RECOMENDED SERVICE BULLETIN

NO. RSB 40-052

Seal between the firewall shield and the fuselage.

“INSTALLATION OF FIREWALL EDGE GUARDS”

DA4-5310-10-00

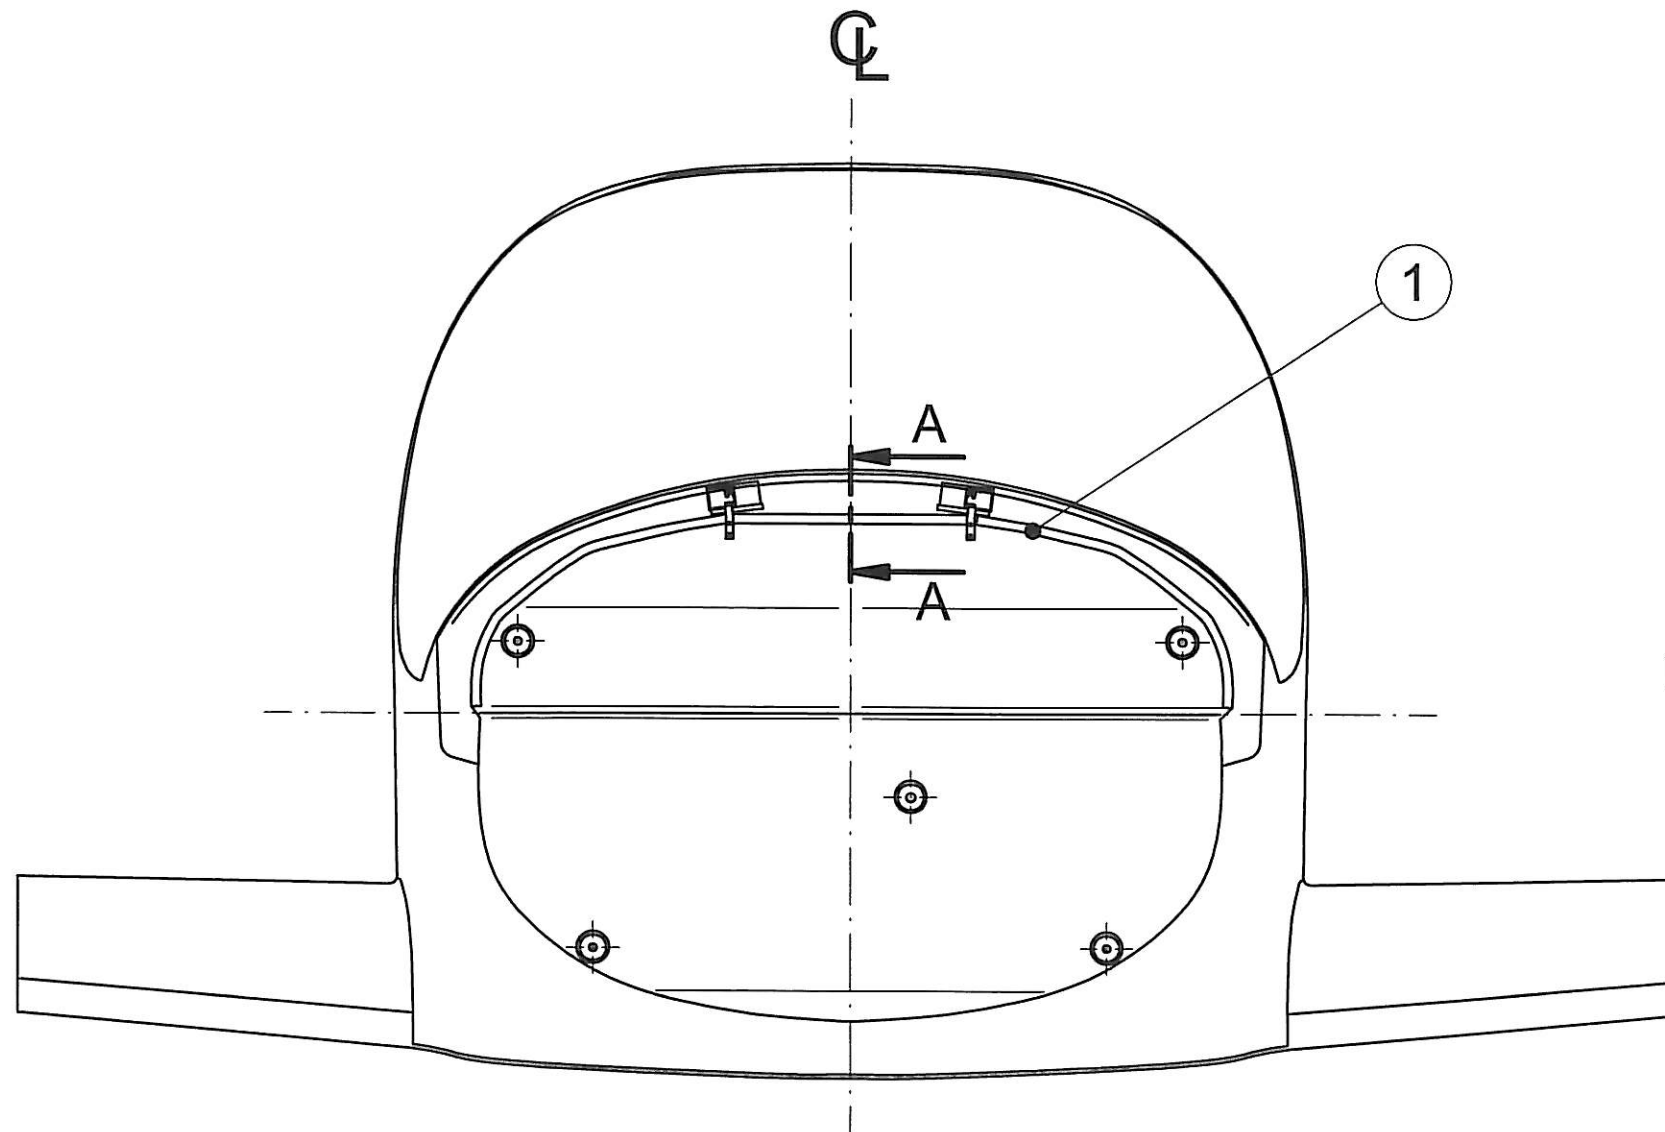
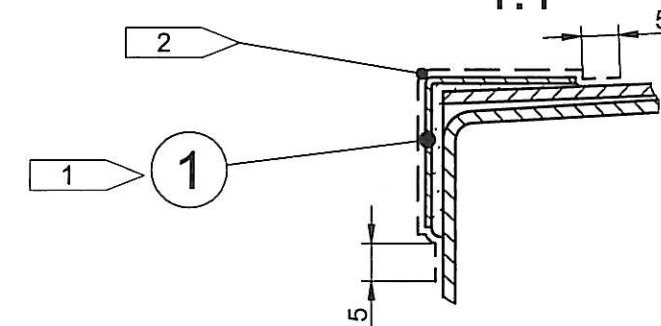
A new seal cover has been approved, which improves the seal of the bond between the firewall shield and the fuselage. The formation of white dust at the bottom edge of the firewall due to moisture in the firewall is prevented.

Improvement of the seal between the firewall shield and the fuselage to prevent moisture ingress.

1	Remove upper and lower cowlings acc. to AMM Section 71.
2	Check that the new seal cover fits proper to the fuselage as shown on drawing DA4-5310-10-00.
3	If it is necessary to trim the seal cover to fit tight to the fuselage, cut small slots into the flange of the seal cover.
4	<p>Mark the outline of the seal cover with masking tape.</p>

5	Grind off fire-paint from the exterior of the fuselage within the outline of the seal cover.
6	Clean surface from dirt and grease. Surface should be solvent wiped and then wiped dry. Refer to AMM Section 51-30.
7	<p>Install seal cover with Terostat 1K-PUR sealant.</p> 
8	<p>Hold seal cover in place with masking tape during cure.</p> 
9	Cure i.a.w. the instructions listed on the Terostat 1K-PUR sealant.
10	After cure, remove the masking tape and excess sealant around the edges.

11	Coat sealant joint and seal cover with fire resistant paint, in acc. with drawing DA4-5310-10-00 and AMM Section 51-30. NOTE: Apply fire protective paint with 5 mm (0.2 in) excess.
12	Clean working area and check for foreign objects.
13	Install upper and lower cowlings acc. to AMM Section 71.
14	Test all systems in working area for function.
15	Make necessary entries into aircraft logs.
